# UNITED STATES PATENT AND TRADEMARK OFFICE

APPLICATION NO.	FILING DATE	FIRST NAMED INVENTOR	ATTORNEY DOCKET NO.	CONFIRMATION NO.
10/088,645	04/18/2002	Joseph Crestin	P22017	7435/

## Office Action Summary

## **DETAILED ACTION**

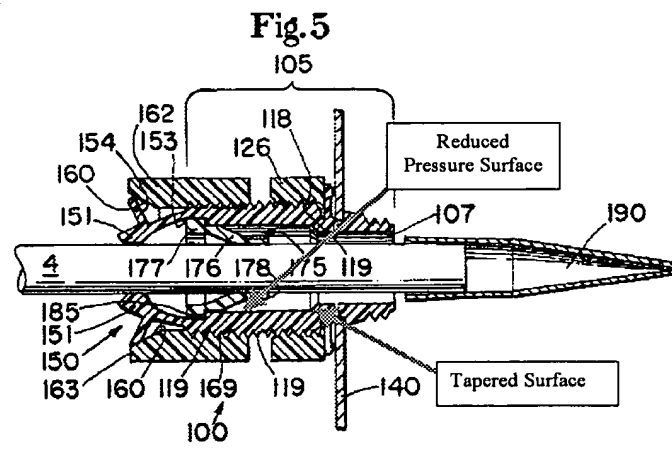
a coupling bushing (105) comprising external threads (119), first nut strips (15) which extend axially beyond the external threads, and a first internal pressure surface (see Figure 5 below);

In regards to claim 8, Sheehan discloses the first and second (see Figure 5 above) internal pressure surfaces comprising tapered surfaces.

To the contrary, it is clear from Fig. 5 that the coupling bushing 119 lacks any internal pressure surface, much less, one that is configured to engage and deform ends of the second nut strips radially inwardly.

The Examiner disagrees. Figure 5 above clearly illustrates an internal pressure surface configure to engage and deform ends of the second nut strips radially inwardly.

The Examiner disagrees. Figure 5 above clearly illustrates a coupling bushing comprising external threads, first strips which extend axially from one end of the coupling bushing, and a first internal tapered pressure surface, wherein the first internal

tapered pressure surface is configured to engage and deform ends of the second strips radially inwardly when the nut moves towards the coupling bushing.
